SERVICE BULLETIN

TS-120S

SUBJECT: TS-120S VFO STABILITY

(SUPERCEDES 7/9/79 BULLETIN)

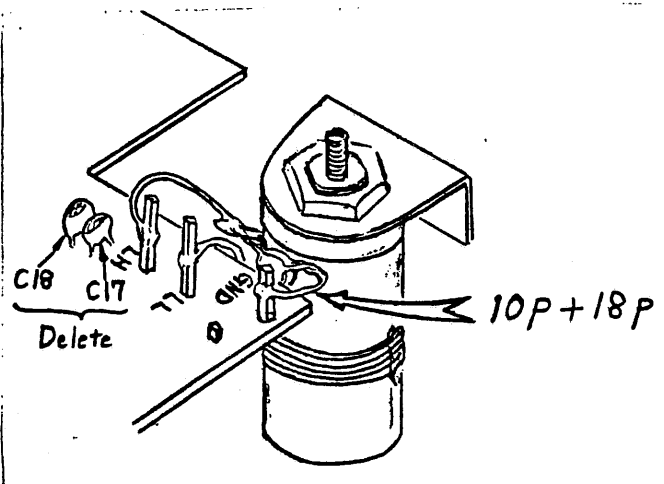
VFO drift characteristics may be improved by changing component values and location in the VFO.

1. Remove the VFO unit by four 3mm hex head bolts.
2. Withdraw out the front panel and unplug the leads.
3. Remove the VFO cover by five Phillips head screws.
4. Remove C17, C18 from the PCB. These may be cut flush to the board.
5. Reposition the Ground terminal for the Variable Capacitor by heating the post and pushing it through to the opposite side of the PCB.
6. Install paralleled 10pF Green and 18pF Yellow caps from the bottom tank coil terminal (LH) to the modified Ground post. Position the caps near the coil, not the PCB. Make certain the ground lead doesn't touch the coil or coil mounting.
7. To reassemble, perform steps 3,2,1. Snug all VFO case screws. A later complaint of frequency jump would indicate a loose VFO shell.

NEW PARTS: 10pF CC45SG1H100J
18pF CC45RG1H180J
